## Response to NuScale Topical Report Audit Question

**Question Number:** A-XPC.LTR-2

Information is needed relative to the methodology assumptions for RCS and ESB mixing in the following areas:

Figure C – Boron transport (dilution) analysis results (RCCW pipe break)

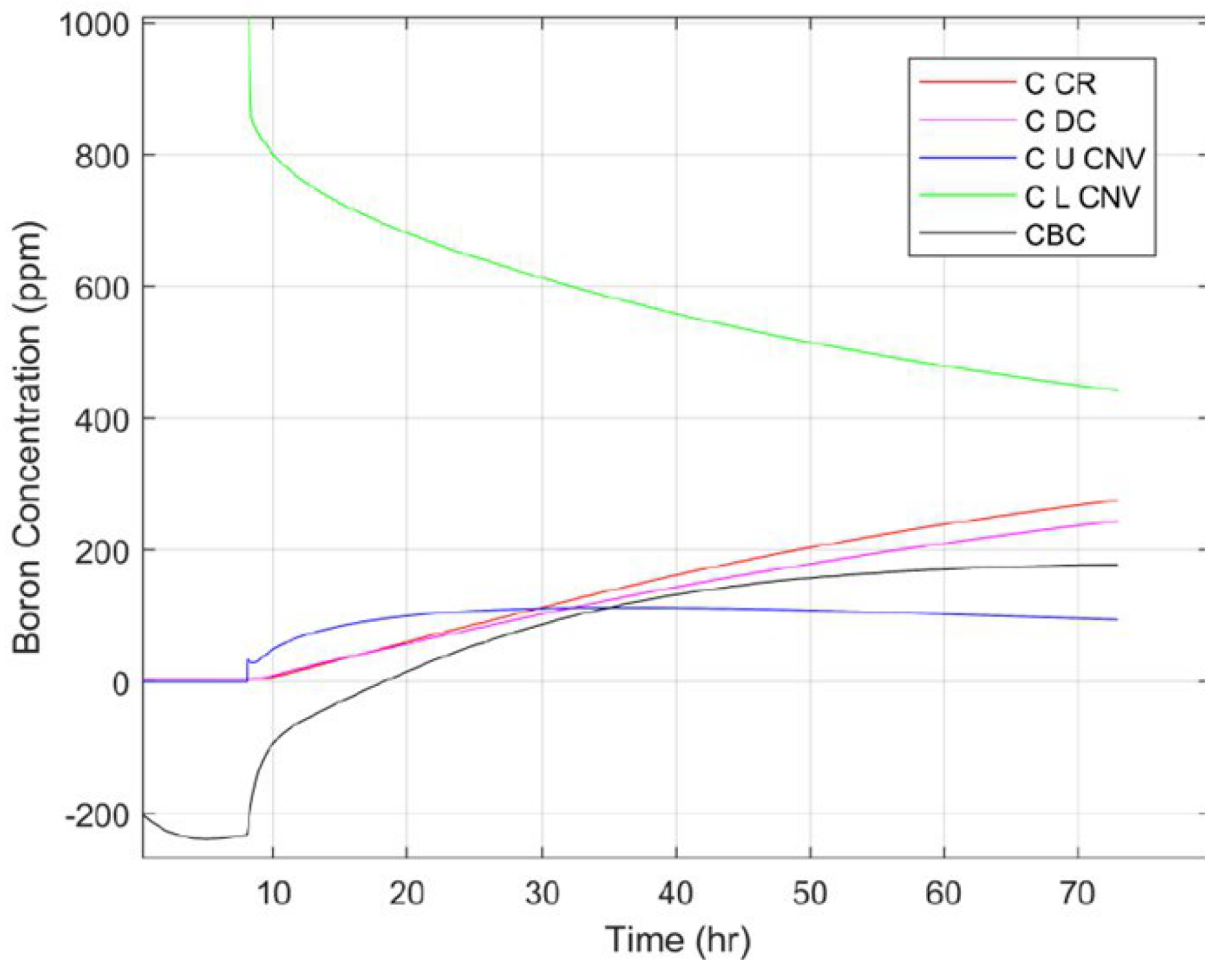
}}<sup>2(a),(c)</sup> (The gradients and flow patterns/behavior in the volumes have not been validated).

{{

}}<sup>2(a),(c)</sup> Therefore, comparing the CFD simulation results to the boron transport analysis results demonstrates conservatism in the CNV mixing assumptions used in the boron transport analysis.
